PWD Comments on Draft EPA Rulemaking

Re: Water Quality Standards to Protect Aquatic Life in the Delaware River
Docket ID No. EPA-HQ-OW-2023-0222

The Philadelphia Water Department (PWD) appreciates the opportunity to submit comments on EPA's Proposed Water Quality Standards to Protect Aquatic Life in the Delaware River dated December 21, 2023, Docket ID No. EPA-HQ-OW-2023-0222, referred to here as the EPA proposed rulemaking.

Figure 1: Comparison of two versions of "restored" dissolved oxygen to observed data at Penn's Landing, DRBC Model and the EPA GAM which was created from the DRBC Model

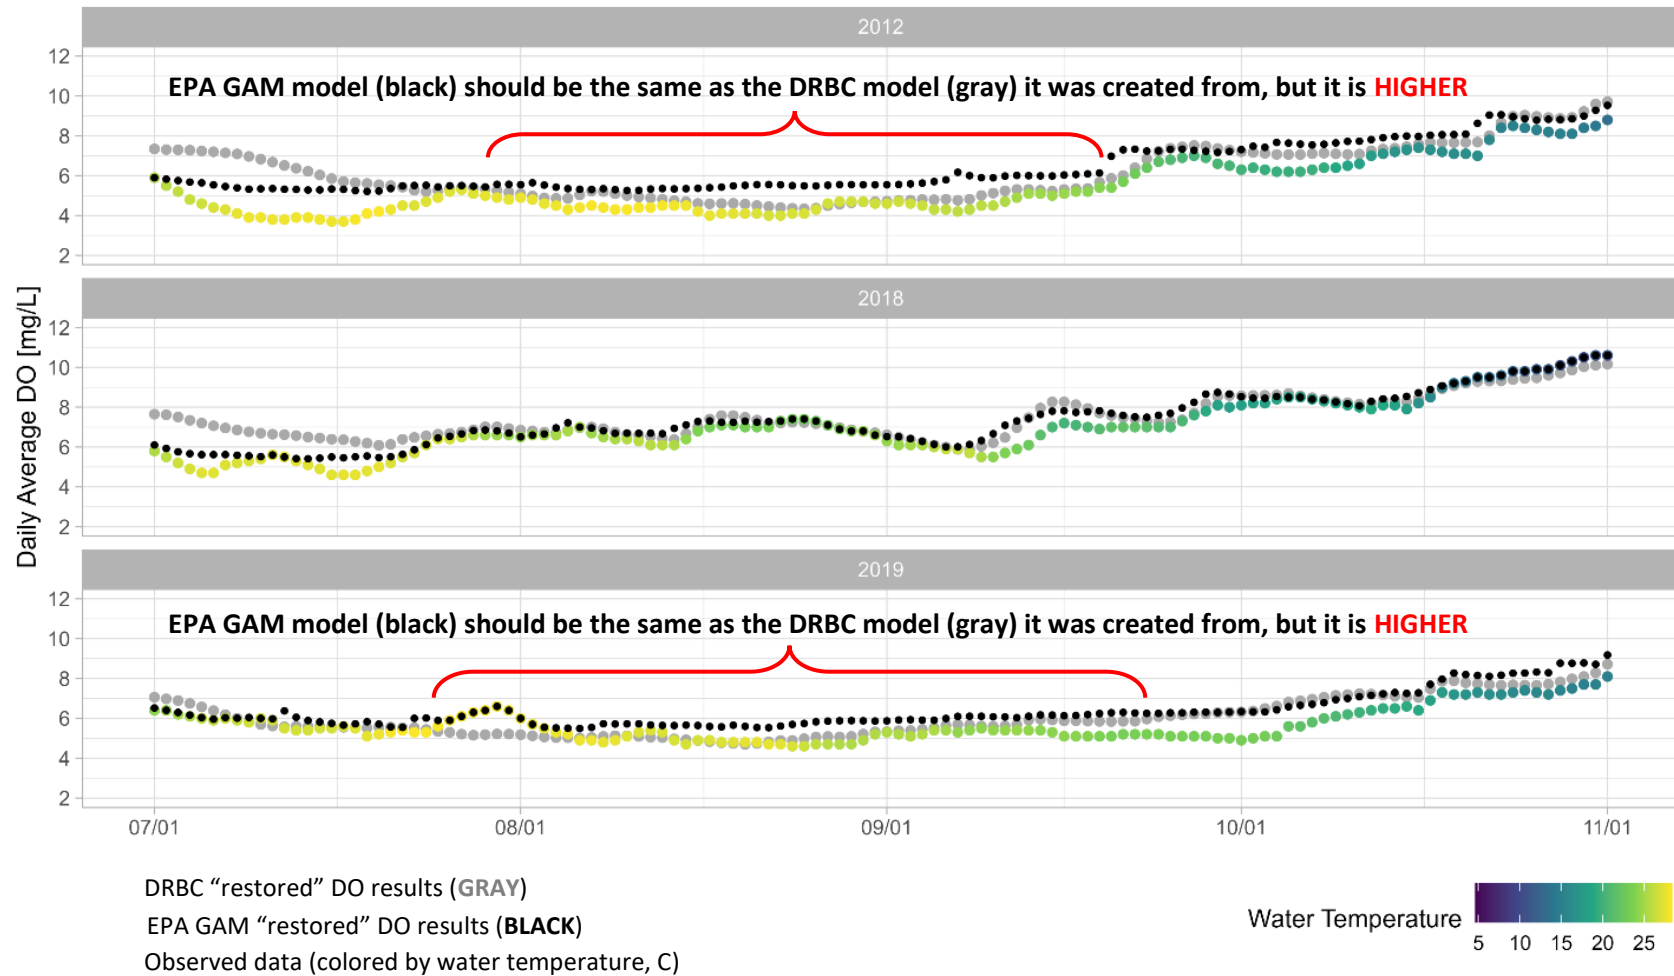
predicting dissolved oxygen. As presented below in Figure 1, the EPA GAM results *are* higher than the DRBC results.

Significant Methodology Limitation: EPA GAM Model Overstates Dissolved Oxygen Improvement from Applied Nutrient Controls

Figure 2: EPA fish cohort model instantaneous mortality rate vs. dissolved oxygen saturation (source: EPA TSD fig. 3)

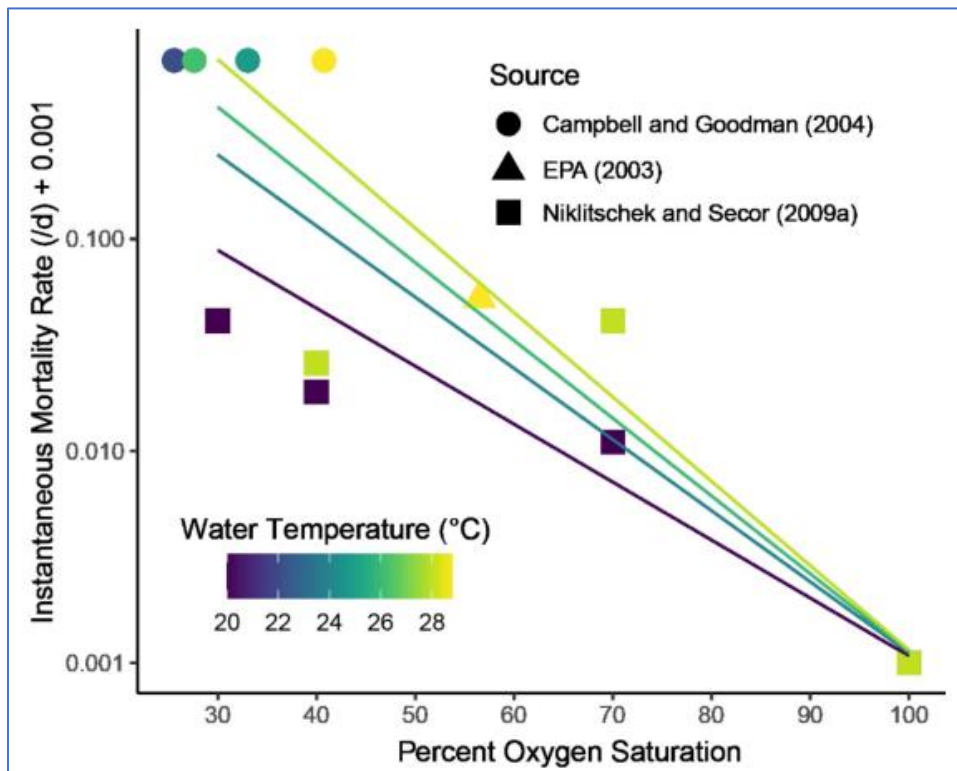
43. Mortality rates in the EPA fish cohort model are incorrect due to flawed and inappropriate laboratory studies.

It is clear from PWD's review of EPA's fish cohort model that: 1.) mortality is a critical component of EPA's fish cohort model, 2.) the availability and consistency of observed data used to parameterize the mortality functions are limited at best, and 3.) the overall effect of these issues results in a high degree of uncertainty in results. The mortality data themselves are inconsistent, such as a higher mortality rate 0.04/d at 70% saturation and 28°C than the 0.025/d mortality rate at 40% saturation and 28°C. The lines fit to model the relationship between mortality and dissolved oxygen do not fit the data well, which is unsurprising because there does not appear to be much of a consistent relationship within the data (Figure 2).

Figure 3: PWD analysis of original sample design from Niklitschek, 2001

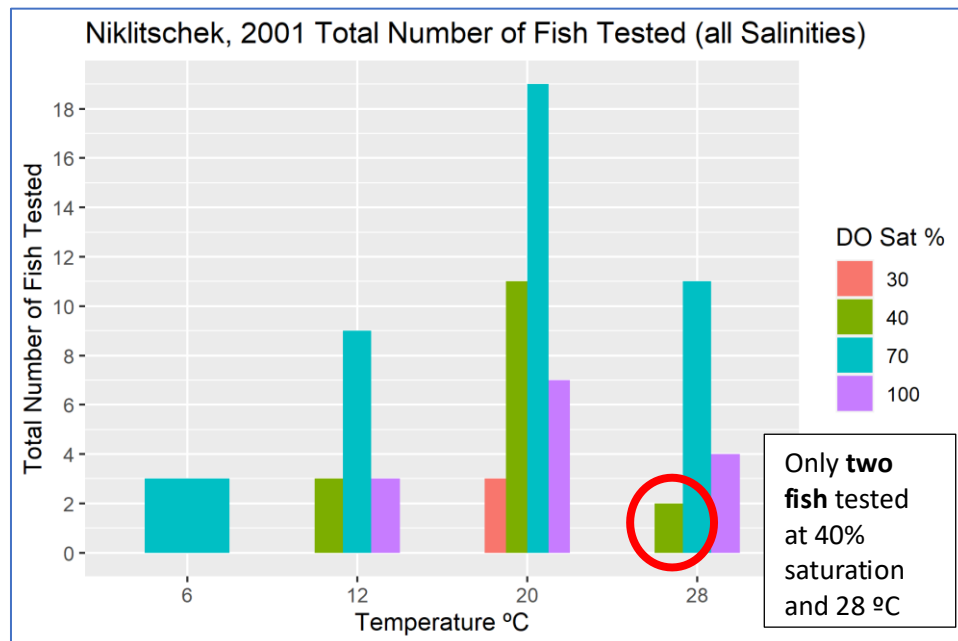
Fitted relationships for growth rates in TSD figure A4-5 show a poor fit to the data, which lack resolution in the crucial area between 40% and 70% saturation which is most relevant to the Delaware River. The observed point for 40% saturation at 28 °C, which critically defines one of the most influential range of

conditions under which growth will be negative or positive in the fish cohort model, is based on *only two fish* (Figure 3, Niklitschek 2001²⁶).

Figure 4: Instantaneous growth rate vs dissolved oxygen saturation (reproduced from Niklitshek & Secor 2009²⁷ Fig. 1)

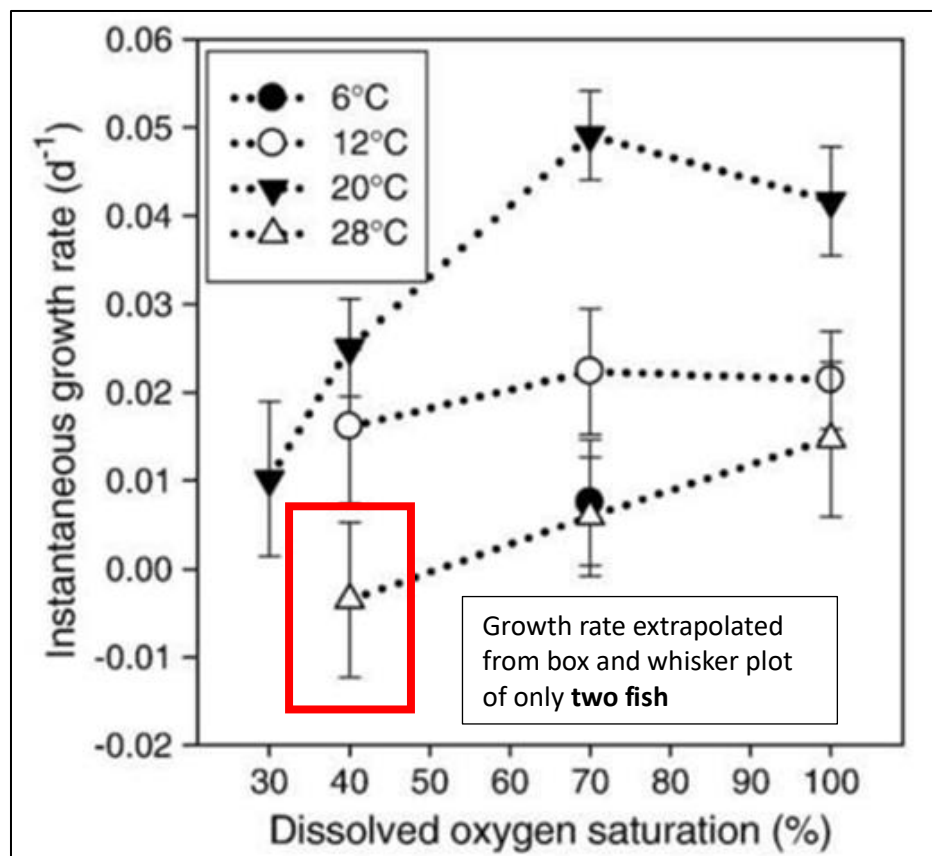
The original plot in Figure 1 of Niklitschek and Secor 2009²⁷ shown below (Figure 4), includes standard error whiskers and points for mean values. Keeping in mind that only *two fish* were tested at 40% saturation and 28 °C, the relatively large standard error, with the upper whisker above 0 indicates that one of the two fish measured had a positive growth rate and one fish had a negative growth rate. If the original data points had been plotted rather than the mean and standard error bars, it would be clear that the sample size and extremely different results make this portion of the growth curve unreliable. With only two fish tested at 40% saturation compared to 11 fish at 70% saturation (Niklitschek 2001²⁶), the difference in growth rates at 28 °C cannot be determined to be different from that which may have occurred due to random chance.

Overall, the fish cohort model is sensitive to the assumptions regarding growth and mortality. In its current state, poor fits to laboratory-derived growth and mortality rates are causing substantial underprediction of the observed data in the model. The uncertainty in observed data, inappropriate, inadequate, and flawed laboratory experimental designs; and poor model fit to mortality and growth data all demonstrate that the fish cohort model is inappropriate for use in a regulatory rulemaking context.

Figure 5: Weight-Length linear regression analysis for Atlantic sturgeon collected from the Delaware River and Hudson River

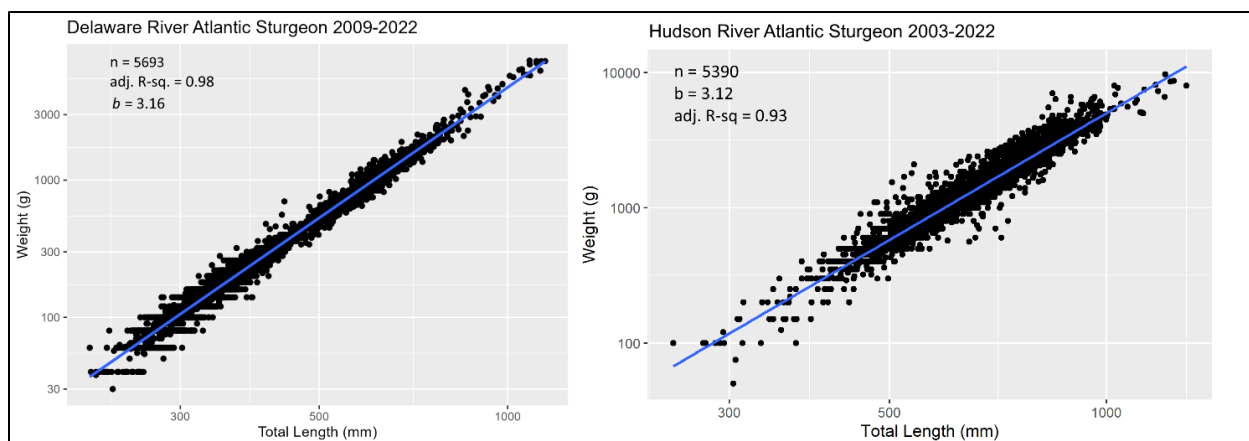
45. Measures of sturgeon growth and health in the Delaware River are similar to the Hudson River, where dissolved oxygen is relatively higher, suggesting that the Delaware River dissolved oxygen levels are adequate.

PWD compared the Delaware and Hudson River populations of sturgeon using a standard fisheries method of linear regression of weight vs length (“W-L” regression). W-L slope parameter b values more than 3 indicate that the fish are becoming “plumper” as length increases (Figure 5) and are usually interpreted as a positive measure of fish population health and well-being. PWD compared the two rivers in multiple ways, finding some small but statistically significant differences in slope between the Delaware River and Hudson with the Delaware usually having a steeper slope. If fish collected from the Delaware River were under stress from low dissolved oxygen levels, it highly unlikely they would have a similar relationship between weight and length – an indicator of how healthy, or plump the fish are – to the Hudson River. Dissolved oxygen stress or poor health would be indicated by “skinny” fish with a lower slope of the weight to length relationship, which was not observed for the Delaware River. Additional details and some important caveats for the comparison between the Delaware River and Hudson River are available in PWD’s Technical Comments on the Evidence for Hypoxia as a Stressor on Delaware River Atlantic Sturgeon.
